DEVIATION REVIEW AND DECISION FORM

Subdivision or Project Name:
Paint Brush Hills Filing 13E

Section of ECM from Which Deviation is Sought: 2.3.7.D.2 Exclusive Right Turn Lane Required

Deviation Exhibit

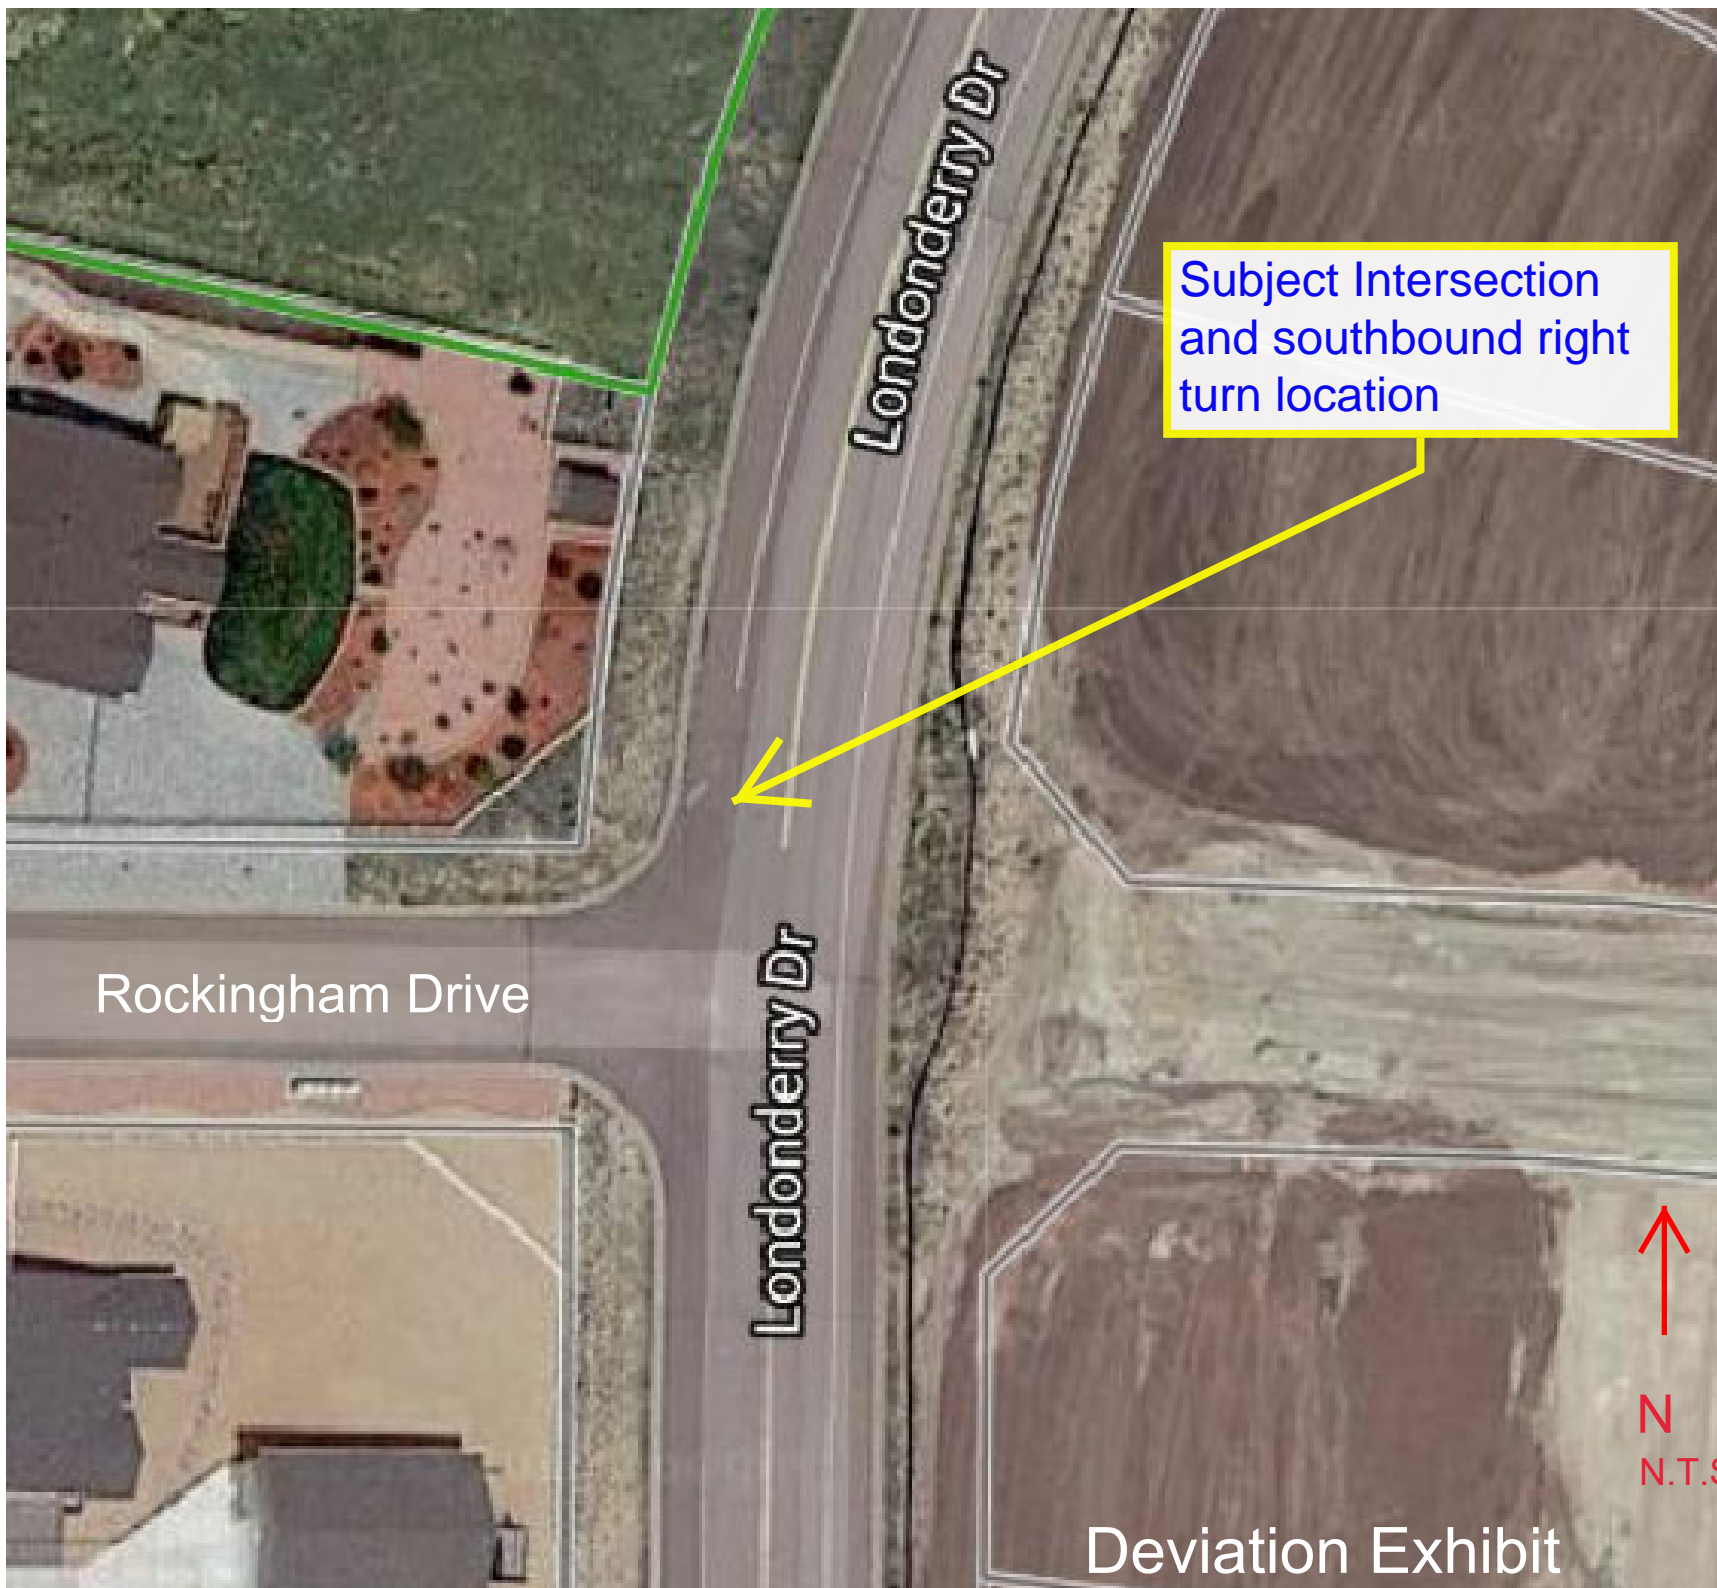
Proposed Nature and Extent of Deviation: Request to waive the requirement for a southbound right turn deceleration lane on Londonderry Drive approaching Rockingham Drive due to the projected low southbound through traffic volumes on Londonderry Drive at this intersection.

Reason for the Requested Deviation: The projected southbound right-turn volume on Londonderry Drive approaching Rockingham Drive is 57 VPH. The combined southbound approach volume on this approach to this intersection is

projected to be 77 VPH. Most of the 77 is comprised of the right turning volume. The projected through volume during the PM peak is only 14 vehicles per hour. This is due to the loop configuration of Londonderry and the anticipated distribution of trips. Based on similar standards used by the Colorado Department of Transportation it is reasonable to waive the need for an exclusive right-turn lane when the projected volumes for the travel lane are low. The projected volume is only 7 VPH above the threshold where a right-turn lane is required by the ECM.

Comparison of Proposed Deviation to ECM Standard: The projected right-turn volume on Londonderry Drive approaching Rockingham Drive is 57 VPH or 7 VPH above the threshold where a right-turn lane is required by the ECM.

Review and Recommendation:
APPROVED by the ECM Administrator
